Charlotte Historic District Commission

Agenda Supplement

September 10, 2025

3. 3105, 3109, 3113, 3117, 3121 Colyer PI (PID 09506133, 09506134, 09506135, 09506136, & 09506137)

ITEM 1: Door and window changes, per Design Standards 6.15

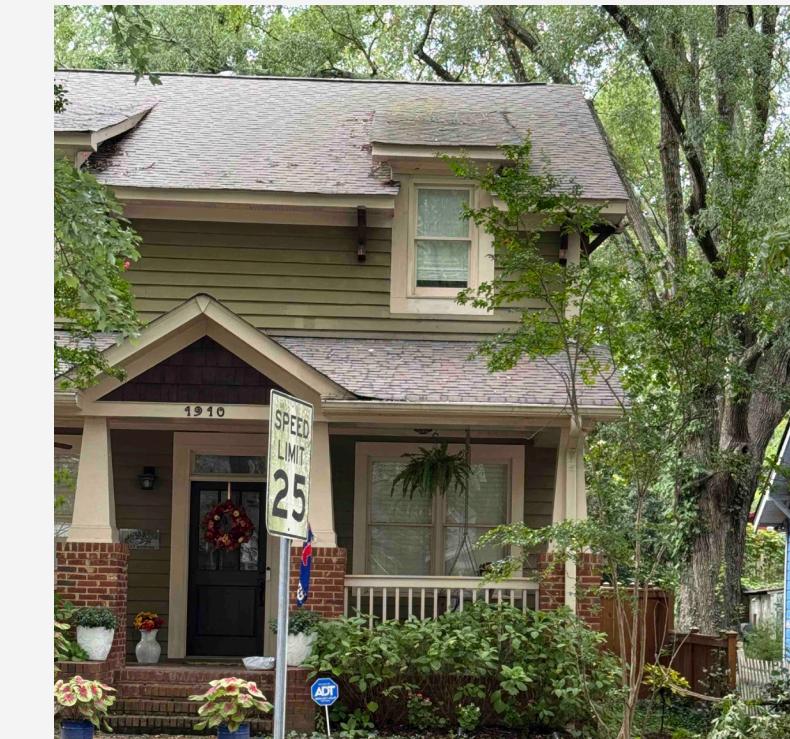
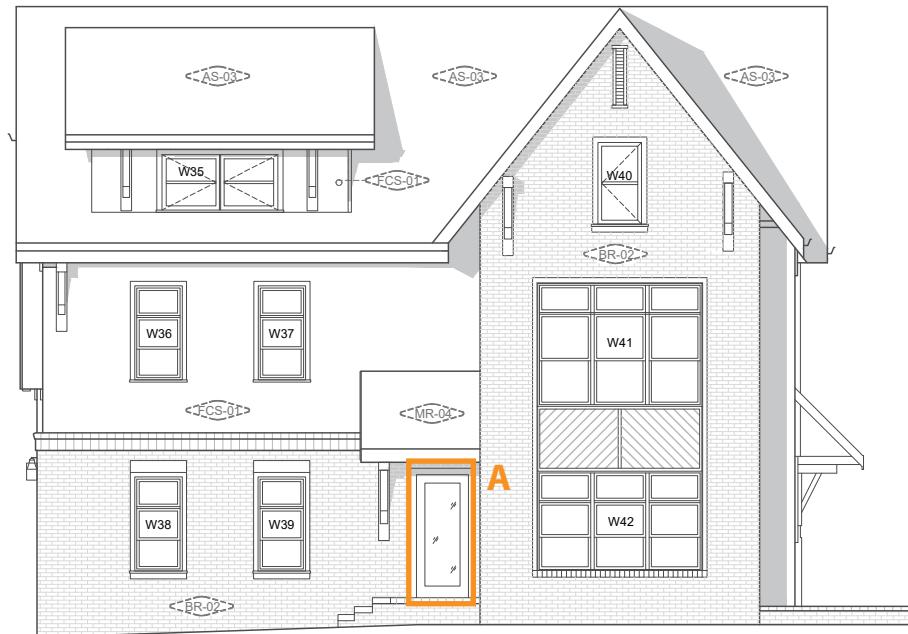
1. Doors and Window Changes, per Design Standard 6.15.

a. No changes are proposed to the plans submitted/reviewed at the July meeting. – The Request of the commission was to further study the window conditions. No Changes to the physical window locations or types due to code requirements and structural framing constraints are proposed in this presentation. Examples of windows not aligning and single over double window types stacked over each other within the district provided.

- A Windows align vertically between floors 2 and 3.
- B Overall proportions are similar to COA approved drawings.
- C Right hand stack of windows are justified approximately 8" further to the right in the as built condition.
- D Header soldier course was omitted to provide space for roof and soffit framing on both sides of the eave.
- E 3rd floor right hand window has different mullion condition to provide egress from bedroom. A true divided light double hung window to match the window below and provide adequate egress from bedroom.

- A Right hand windows align vertically between floors 2 and 3 and are per COA approved Drawings.
- B Left hand windows do not align vertically between floors 2 and 3. Third floor window is more narrow and generally aligned with the center of the 2nd floor window below.
- C Header soldier course was omitted to provide space for roof and soffit framing on both sides of the eave.
- D 3rd floor left hand window has different mullion condition to provide egress from bedroom. A true divided light double hung window to match the window below and provide adequate egress.

FRONT ENTRANCE / PUBLIC FACING SINGLE LITE GLASS DOORS

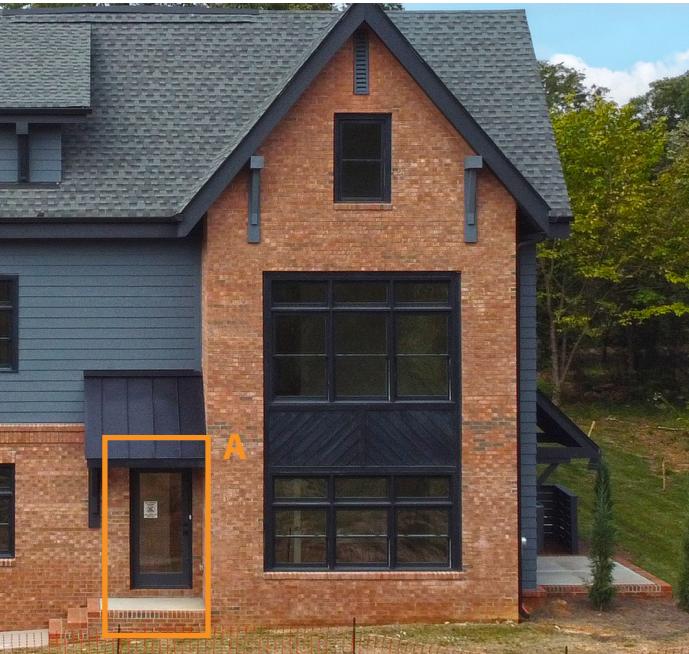
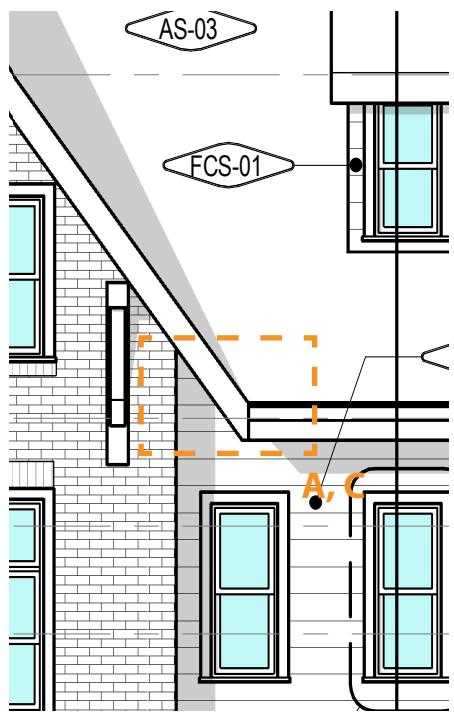
- A** A restudy of the public facing single lite doors has been conducted per the commissions request. Upon canvassing the immediate surrounding area in the District, there are multiple instances of single lite entrance doors on historic structures.

Most notably 1409 and 1801 Thomas Avenue. It should be noted that these are single lite entry doors, not all glass storm doors with a multi lite door behind. This is evidenced by the full entrance hardware and deadbolts that can be seen in the photographs.

ITEM 2: Cornice and trim changes, per Design Standards 6.14

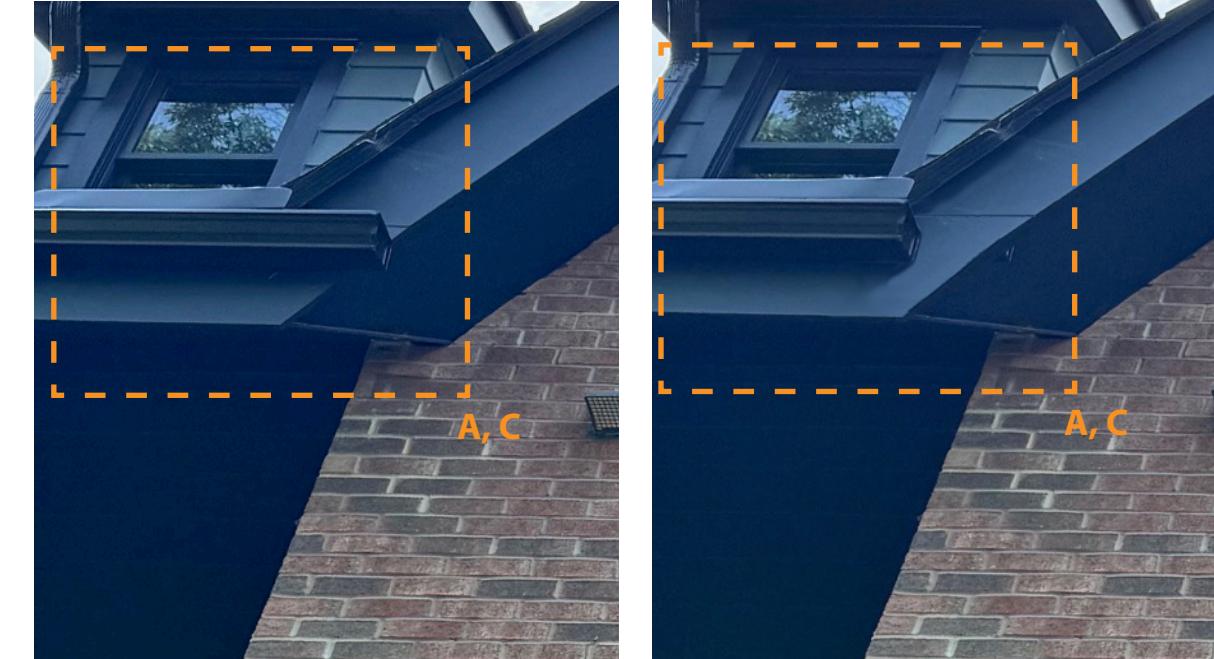
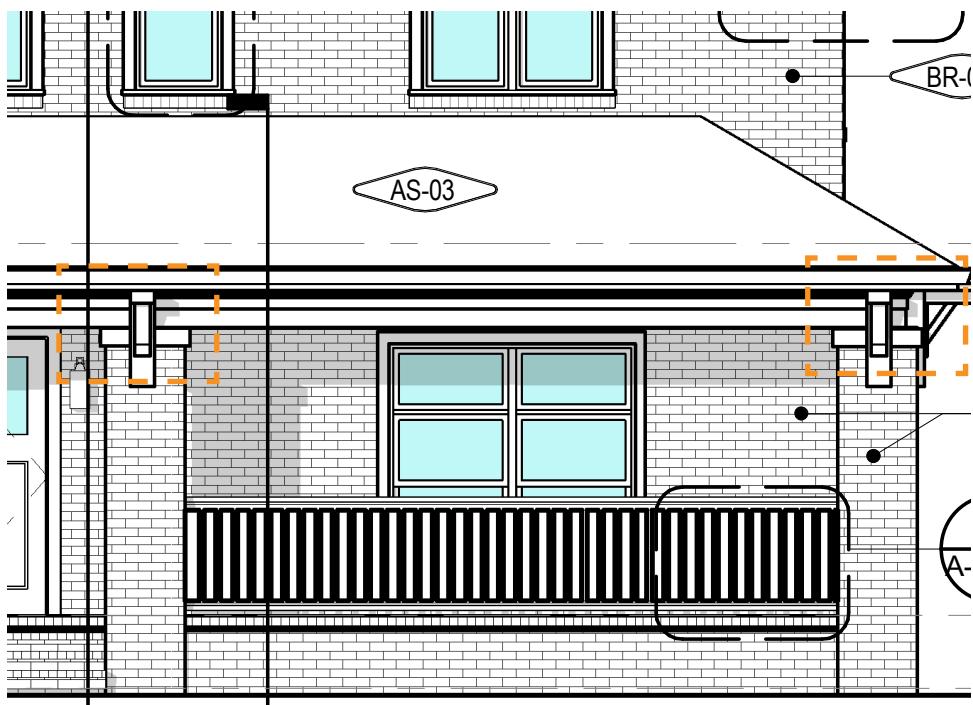
2. Cornices and Trim Changes per Design Standard 6.14.

a. No changes are proposed to the plans submitted/reviewed at the July meeting. – This is incorrect. Upon further study the inconsistent cornice and trim details, it has been observed that the trim detail is been installed in a consistent manner around the building. The gutter terminations are inconsistent. It is proposed to rework the gutters into a consistent termination point as shown in the before and after photoshop images.

B In general, the trim work is consistent with the elevations in the approved COA drawings. The inconsistent appearance between different locations around the building appear to be a result of inconsistent gutter installations.

IT IS PROPOSED that Inconsistent detailing to be normalized throughout the property by trimming the gutters back to a consistent length in relation to the termination of the cornice / eave detail. Examples of this are provided on this page as "before and after" images. The "before" images consist of as built photographs. The "after" images are those same photographs, altered in photoshop to provide the commission with the most accurate visual representation of the desired outcome of the proposed changes

ITEM 3: Column Details, per Design Standards for Masonry 5.5 and Trim 6.14

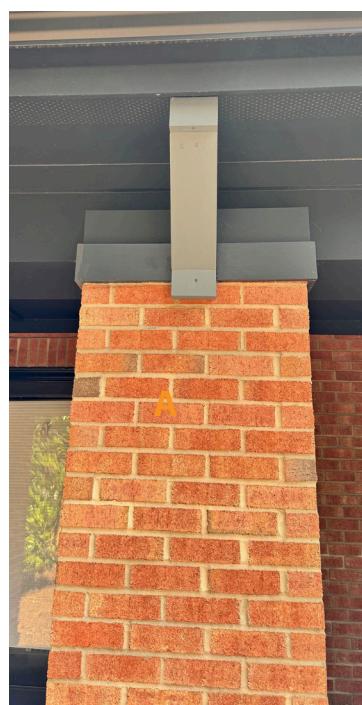
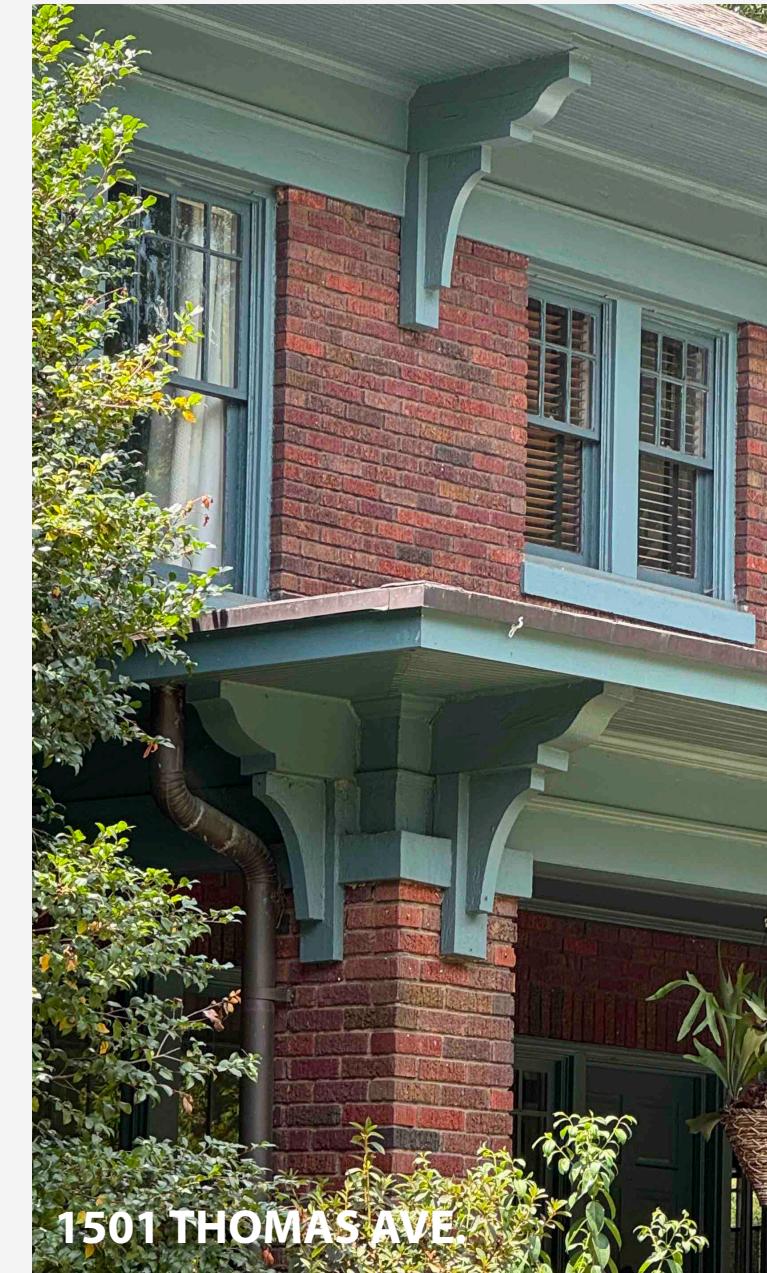
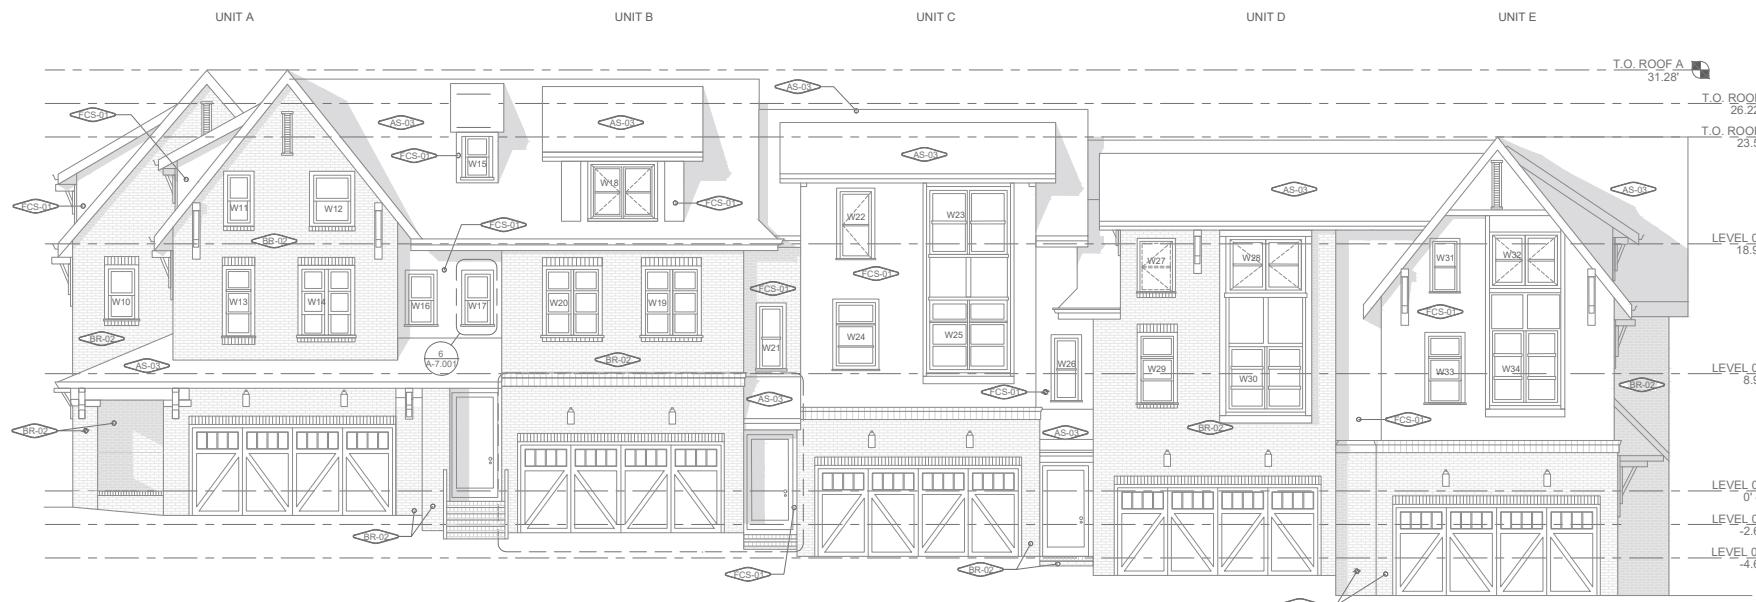
3. Column details, per Design Standards for Masonry, 5.5 and Cornices and Trim, 6.14. – No Changes are proposed at the column capitals and trim. Examples of similar conditions in the district have been provided for precedent.

A A re-study of the front porch columns reveal they are built as drawn and approved COA Drawings. In addition, there are multiple examples of masonry wood capped structures in the immediate surrounding district on historic structures.

Most notably, 1501 Thomas Avenue has a very similar condition incorporating the eave bracket design into the column capital design and relationship with horizontal beam/soffit trim work.

VDL columns appear to be constructed consistently with the approved COA drawings and contextually relevant historic precedents within the district. - There are no proposed changes as the comments received question the contextual relevance not the as-built condition.

PROPOSED POST CONSTRUCTION CHANGES - SOUTH ELEVATION

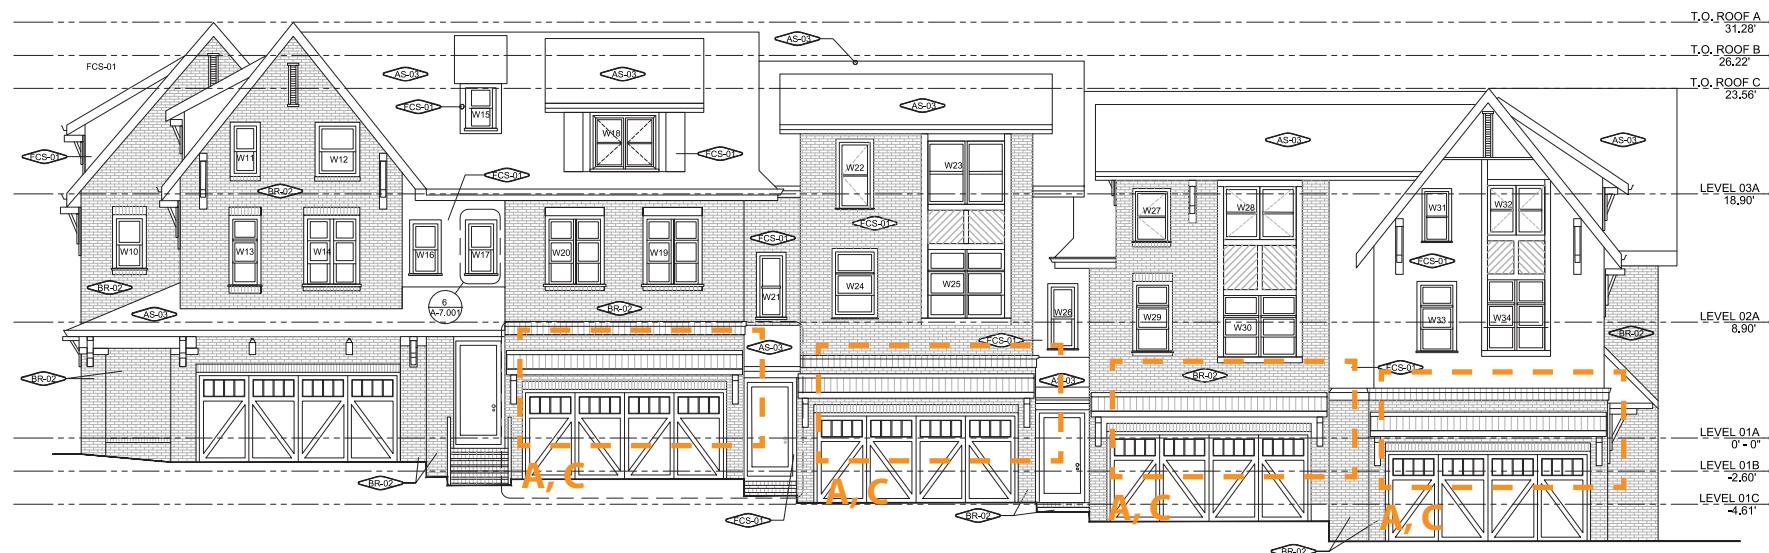
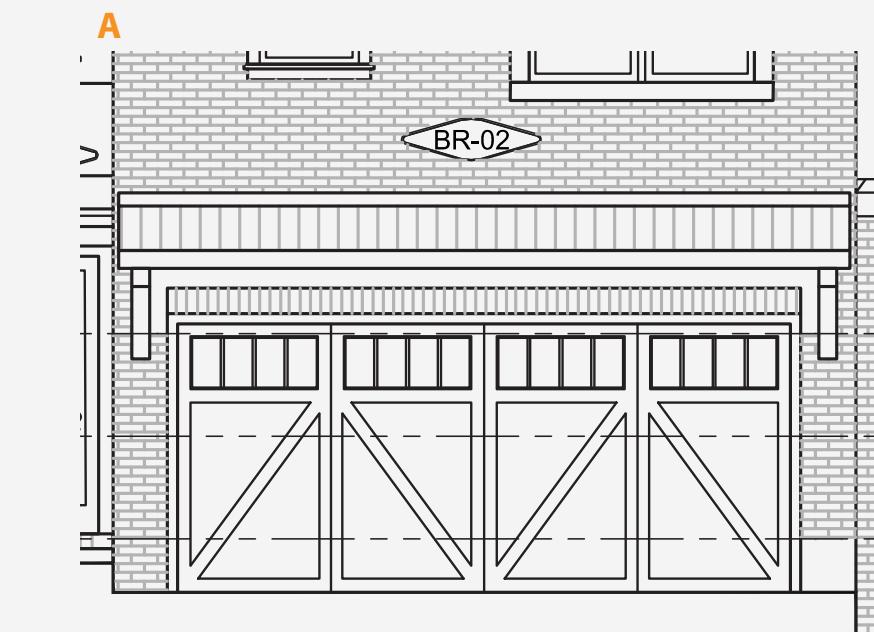
- a. The addition of wood trellis with small brackets above the garage doors does not match the architectural style of the rest of the building. Trellis has been replaced with a small shed roof and brackets consistent with the detailing of the project. Lighting shall be changed to concealed/recessed soffit lights- exterior sconces where trellis is utilized will be omitted as there is not enough space in the brick and do not make architectural sense to be located above a solid roof. Relocating the sconces to the sides of the garage door is not an option

- b. The diagonal siding in the double panels under triple windows will be replaced with three smooth finish fiber cement panels that align with the triple windows.

- c. The brick sill on above the front porch roof of Unit 3105 is still covered with flashing, and no alternative has been proposed. – As explained in the presentation, The depth of flashing at masonry walls is minimally sized in the vertical direction to provide adequate protection from water intrusion and is a typical detail seen throughout Historic Districts on chimneys (step flashing) and porches based on current building technologies, manufacturers installation requirements and general best practices.

- d. Light Fixtures:
- 6i. ii. No new location for light fixtures has been provided. – See response to item 4A above Lighting shall be changed to concealed/recessed soffit lights- exterior sconces where trellis is utilized will be omitted as there is not enough space in the brick and do not make architectural sense to be located above a solid roof. Relocating the sconces to the sides of the garage door is not an option

- A** To reduce the visual proportions of brick above garage doors we are proposing adding a wood trellis designed and built consistent with the corner bracket details approved in the COA Documents. The dimensions of the brackets will match the "small brackets" at the porch column capitals for consistency and to bring a pedestrian level scale to the garage door openings and alley way.

- B** It is proposed to omit the diagonal siding at these locations requiring three panels to align with window mullions. A third panel will be added to align with the mullions of the windows above and below with a smooth fiber cement panel painted to match the trim color.

- C** Due to structural posts and headers surrounding the doors, the lights cannot be relocated to the side of the doors per the approved COA drawings. We are proposing an alternative light fixture that is an appropriate appearance and use for above door applications. Additionally, this will carry more visual weight than the current fixtures further minimizing the amount of noticeable brick between the first and second floors

- D** Evaluating the brick flashing detail reveals the design initially presented and approved in the COA is not adequate to provide adequate water intrusion measures. The depth of flashing at masonry walls as installed is minimally sized in the vertical direction to provide adequate protection from water intrusion and is a typical detail seen throughout Historic Districts on chimneys (step flashing) and porches based on current building technologies, manufacturers installation requirements and

PROPOSED POST CONSTRUCTION CHANGES
EAST ELEVATION

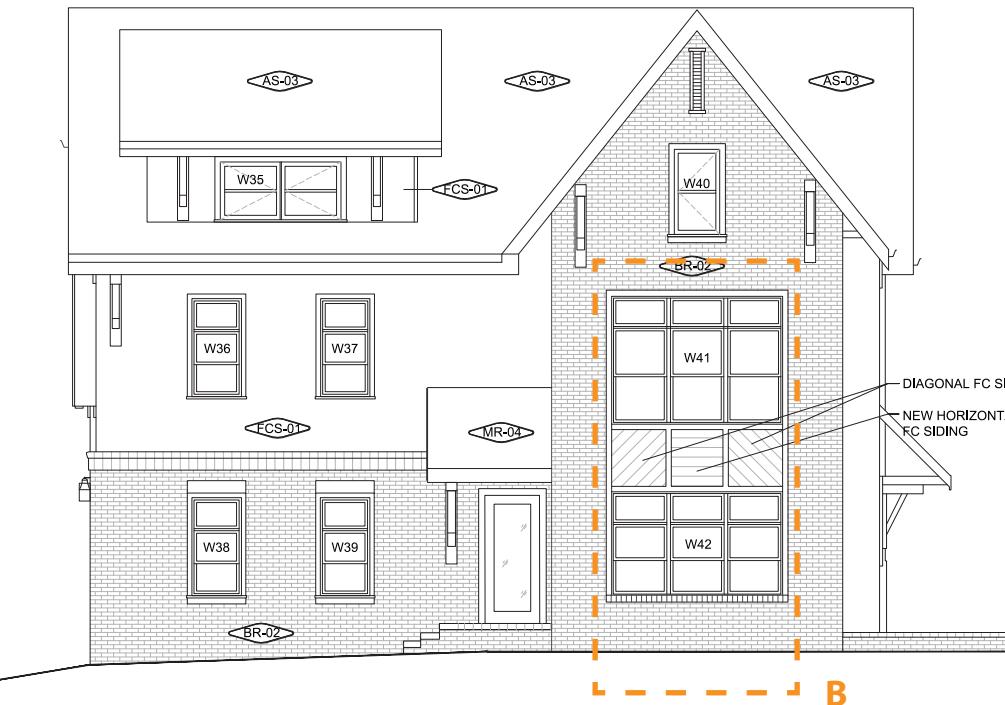
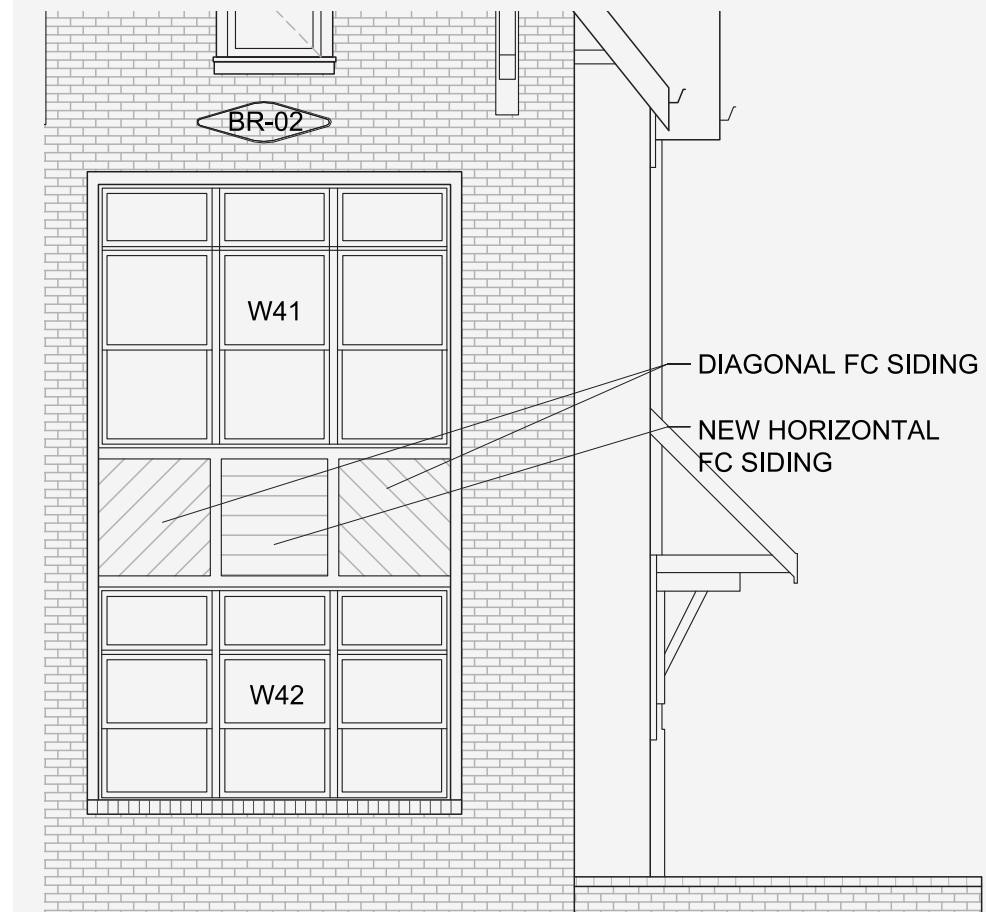
- i. The change to smooth paneling is more contemporary and does not match the architectural style of the rest of the building. – Three panels added per COA Documents. Side panels shall have diagonal siding per COA Documents. Middle panel shall have Horizontal siding. Smooth panels have been omitted from proposal.

- ii. Trim detailing around the revised panels has not been specified. Trim shall be Painted fiber cement consistent with COA Documents with dimensions to match the window mullion and spacing of the windows above and below.

- iii. It is unclear if the remaining panels with diagonal siding will remain as-is or also switch to a smooth finish. -All diagonal trim panels shall remain per the approved COA documents

B It is proposed to modify the diagonal siding at these locations to allow for the three panel design approved in the COA documents. The three panels shall align with window mullions. The two outer panels shall have diagonal siding to match the COA approved design intend and the new middle panel shall be infilled with a horizontally run siding to mathch the horizontal siding of the townhomes. The exposeddimensipoon of the siding dshall be consistent between the diagonal and horizontal panels.
